AMENDMENTS TO THE DRAWINGS

REMARKS

Objections to the Drawings

Fig. 1

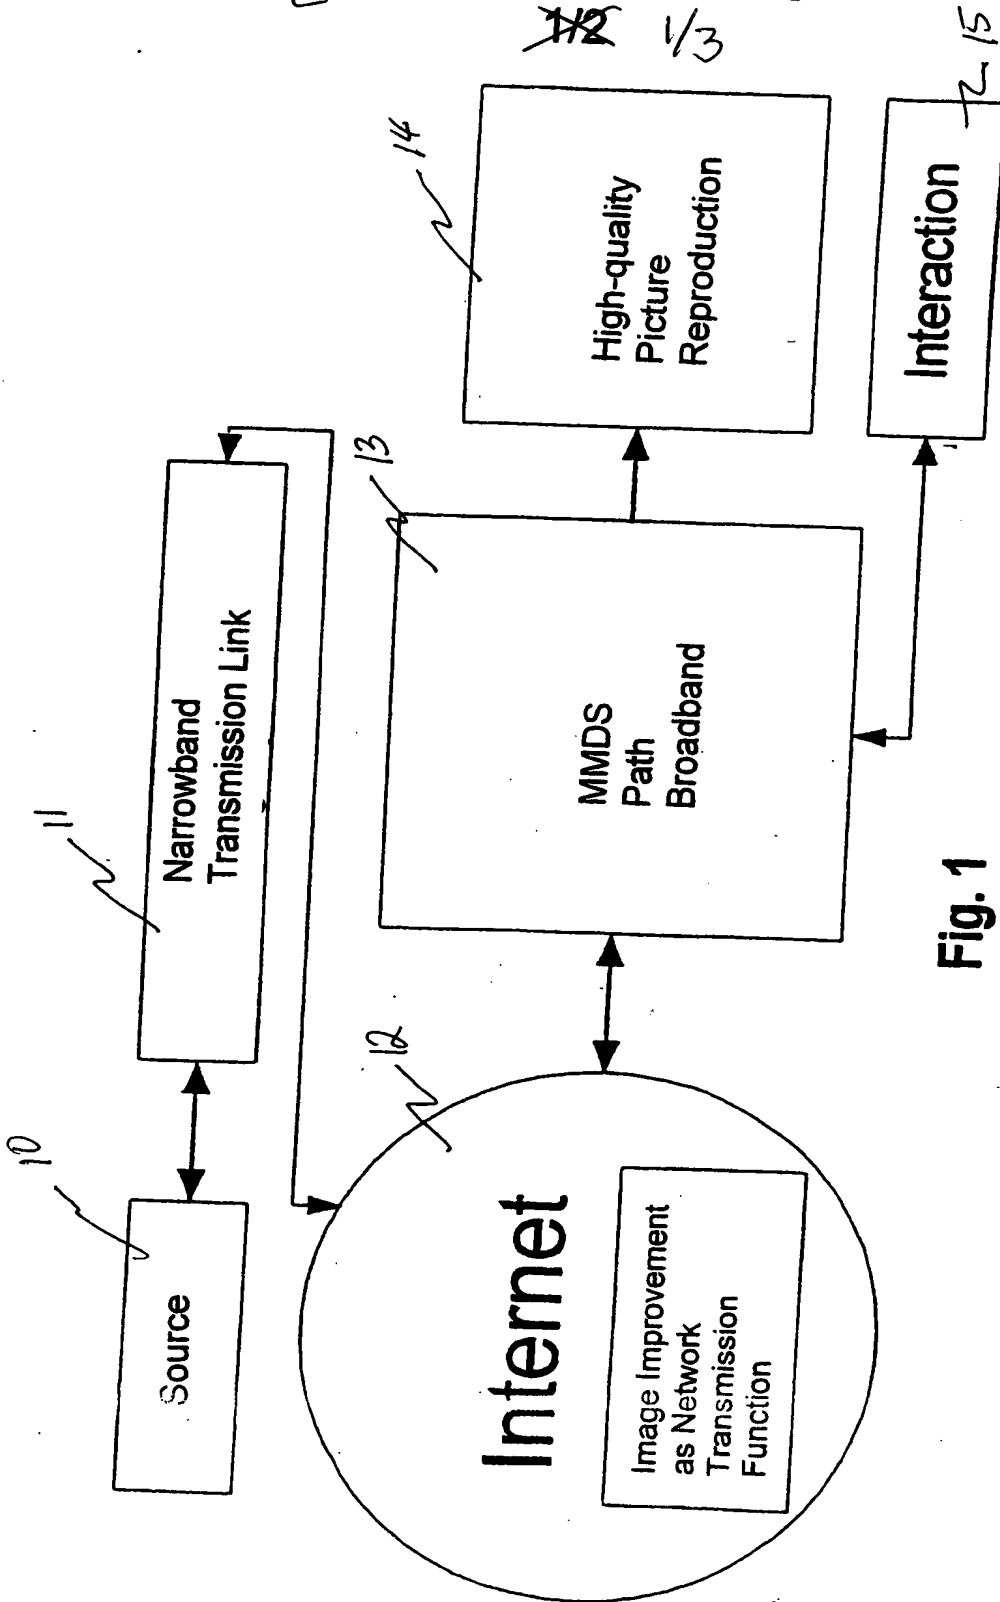
Figs. 1 and 2 were objected to for showing [REPLACEMENT] in the wrong location. And, Fig. 2 was objected to for the non-numerical references. In accordance with the Examiner's request, Applicants have amended Figs. 1 and 2 to remedy those situations, and Figs. 1 and 2 are submitted herewith for acceptance by the Patent Office.

The attached sheets of drawings includes changes to Figs. 1 and 2. The [REPLACEMENT] sheet of Fig. 1 replaces the original Fig. 1 sheet; the [REPLACEMENT] sheet of Fig. 2 replaces the original Fig. 2 sheet. Figs. 1 and 2 are amended to properly show [REPLACEMENT] and references.
